Road & Bridge Design Publications

Monthly Update – July 2023

Revisions for the month of **July** are listed and displayed below and will be included in projects submitted for the **November** letting. The special detail index from **April** will remain in effect.

MICHIGAN DEPARTMENT OF TRANSPORTATION
 BUREAU OF DEVELOPMENT
 PIER DIAPHRAGMS FOR PRESTRESSED CONCRETE
 BEAMS CONTINUOUS FOR LIVE LOAD

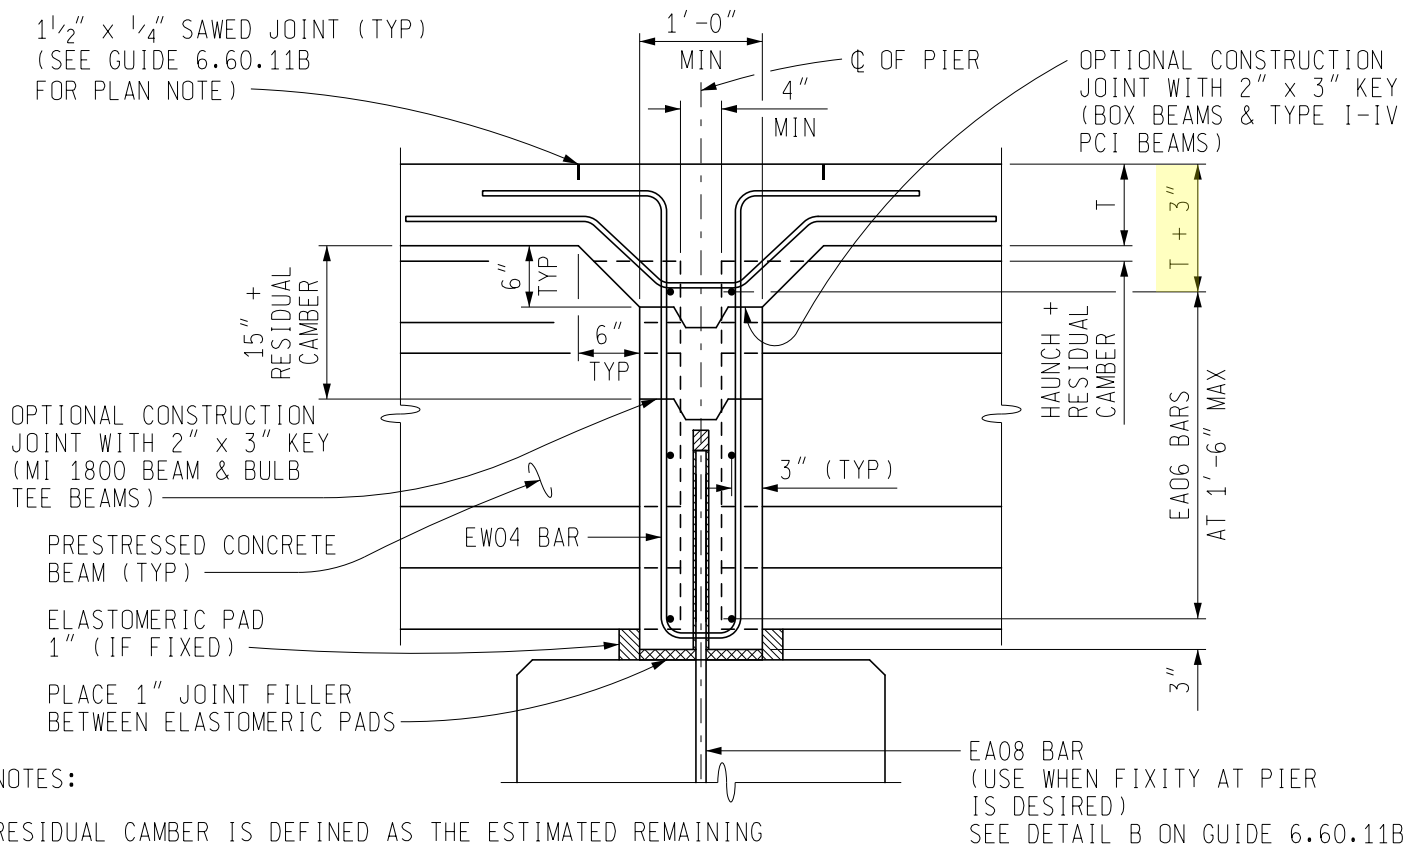
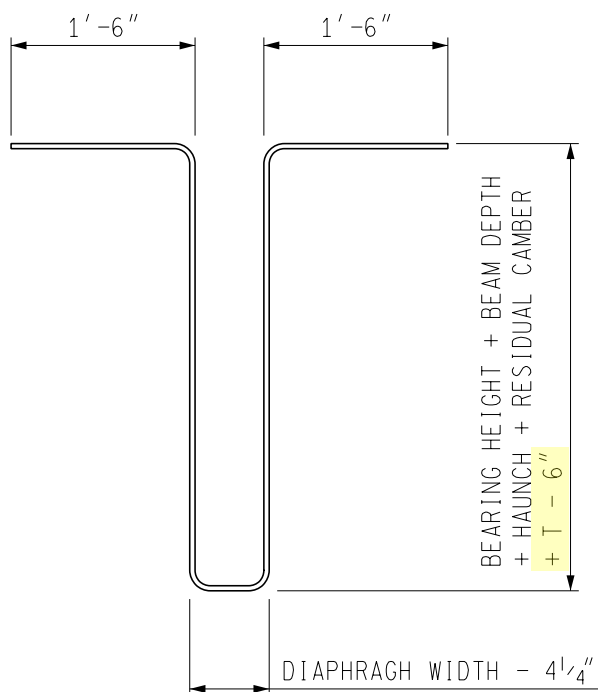
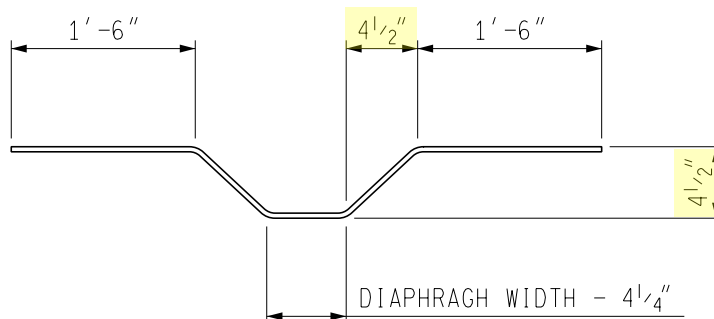
6.60.11 & 6.60.11A: Redefined location of transverse EA 06 bars and updated dimensions for EW bars within diaphragm.
